**SUBJECT: RIVER BEND STATION, UNIT 1 - STAFF ASSESSMENT OF INFORMATION PROVIDED PURSUANT TO TITLE 10 OF THE *CODE OF FEDERAL REGULATIONS* PART 50, SECTION 50.54(f), SEISMIC HAZARD REEVALUATIONS FOR RECOMMENDATION 2.1 OF THE NEAR-TERM TASK FORCE REVIEW OF INSIGHTS FROM THE FUKUSHIMA DAI-ICHI ACCIDENT (TAC NO. MF3706)**

STAFF ASSESSMENT BY THE OFFICE OF NUCLEAR REACTOR REGULATION

RELATED TO SEISMIC HAZARD AND SCREENING REPORT

RIVER BEND STATION, UNIT 1

Figure 3.3-1 Plot of Staff's and Licensee's Base Case Shear-Wave Velocity Profiles for the RBS Site

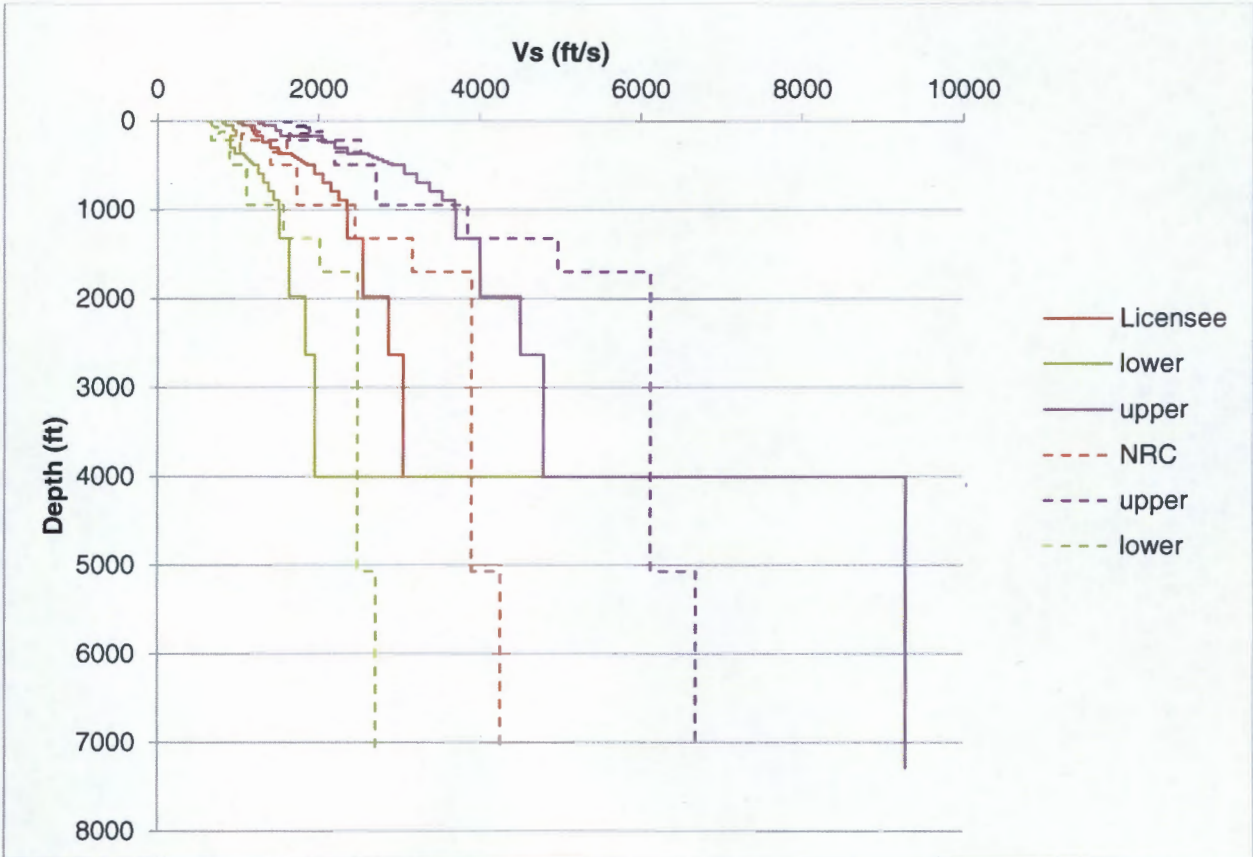
200 ft (61 m) of its base case shear wave velocity profile, the NRC staff used the data provided in UFSAR Table 2.5-10. The NRC staff extended its base case velocity profile to a depth of about 1000 ft (305 m) using COL data and then used the generic gradient recommended in the SPID to extend the profile to a depth of 7000 ft (2,134 m). To develop the upper and lower base case velocity profiles, the NRC staff used a natural log standard deviation of 0.2. Figure 3.3-1 of this assessment shows a comparison of the three base case velocity profiles developed by the licensee with those developed by the NRC staff. The profiles developed by the licensee are similar in shape to those developed by the NRC staff. However, the staff's profiles extend to greater depth than the licensee's and are generally faster at depths greater than approximately 1,000 ft (305 m).

Figure 3.3- 2 Plot Comparing the Staff's and the Licensee's Median Amplification Functions and Uncertainties for the RBS site.

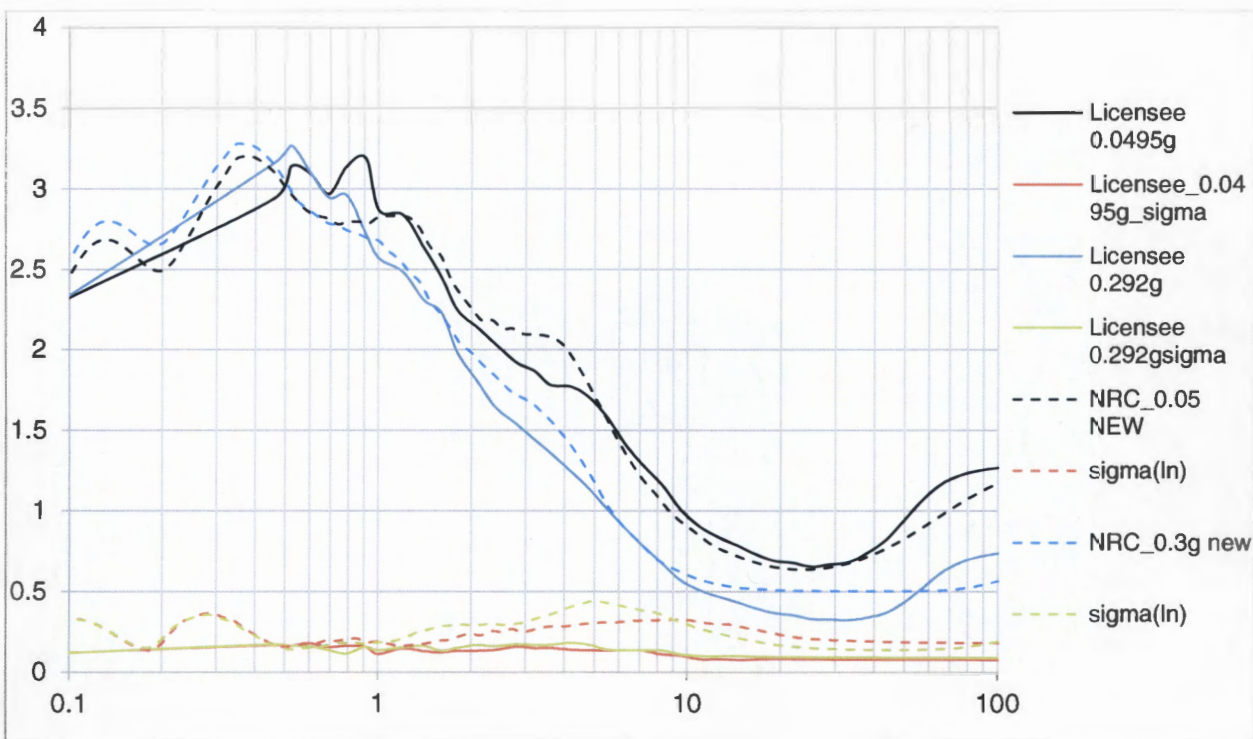
Figure 3.3-2 of this assessment shows a comparison of the staff's and the licensee's median site amplification functions and uncertainties ( $\pm 1$  standard deviation) for two of the eleven input loading levels. The peak in amplification functions occurs between approximately 0.4 and 1.0 Hz in both the staff's and the licensee's curves. Differences in site amplification curves developed by the NRC staff and the licensee are due primarily to differences in site velocity profiles and are minor. As shown in Figure 3.3-3 of this assessment, these differences in site response have a modest impact on control point seismic hazard curves and the resulting GMRS, discussed below. Appendix B of the SPID provides guidance for performing site response analyses, including capturing the uncertainty for sites with less subsurface data. However, the guidance is neither entirely prescriptive nor comprehensive. As such, various approaches in performing site response analyses, including the modeling of uncertainty, are acceptable for the 50.54(f) response.

**Figure 3.3-3 Plot Comparing the Staff's and the Licensee's Mean Control Point Hazard Curves at a Variety of Frequencies for the RBS site**

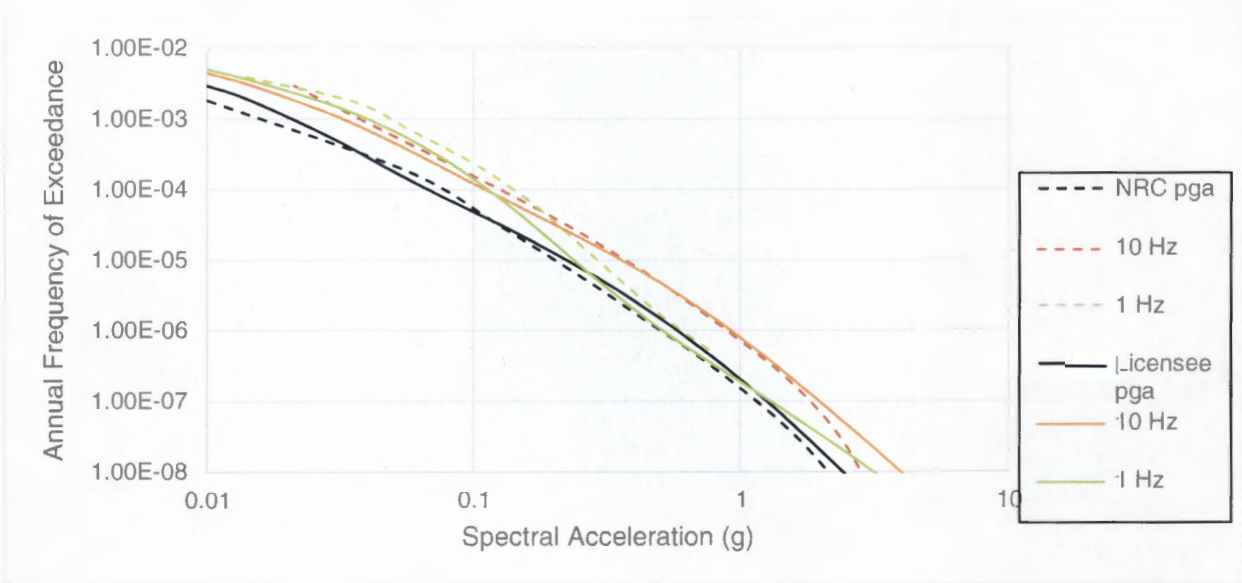
In summary, the NRC staff concludes that the licensee's site response was conducted using present-day guidance and methodology, including the NRC-endorsed SPID. The NRC staff performed independent calculations to confirm that the licensee's amplification factors and control point hazard curves adequately characterize the site response, including the uncertainty associated with the subsurface material properties, for the RBS site.

Figure 3.4-1 Comparison of the Staff's GMRS with Licensee's GMRS and the SSE for the River Bend Station site

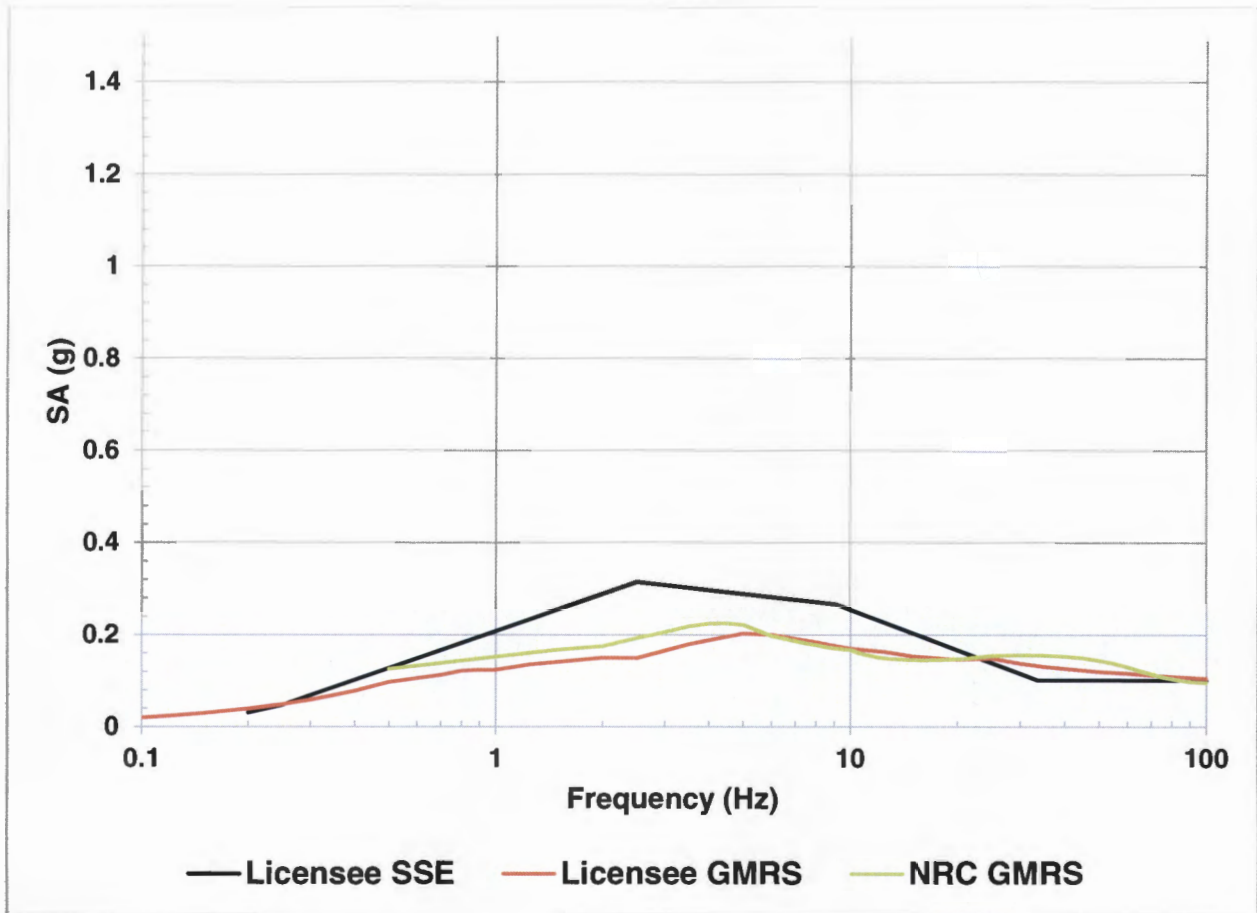
The NRC staff independently calculated the  $10^{-4}$  and  $10^{-5}$  UHRs using the results of its confirmatory PSHA and site response analysis, as described in Sections 3.2 and 3.3 of this staff assessment, respectively. As shown in Figure 3.4-1 below, the licensee's GMRS shape is very similar to that calculated by the NRC staff.

The NRC staff confirms that the licensee used the present-day guidance and methodology outlined in RG 1.208 and the SPID to calculate the horizontal GMRS, as requested in the 50.54(f) letter. The NRC staff performed both a PSHA and site response confirmatory analysis and achieved results consistent with the licensee's horizontal GMRS. As such, the NRC staff concludes that the GMRS determined by the licensee adequately characterizes the reevaluated hazard for the RBS site. Therefore, this GMRS is suitable for use in subsequent evaluations and confirmations, as needed, for the licensee's response to the 50.54(f) letter.
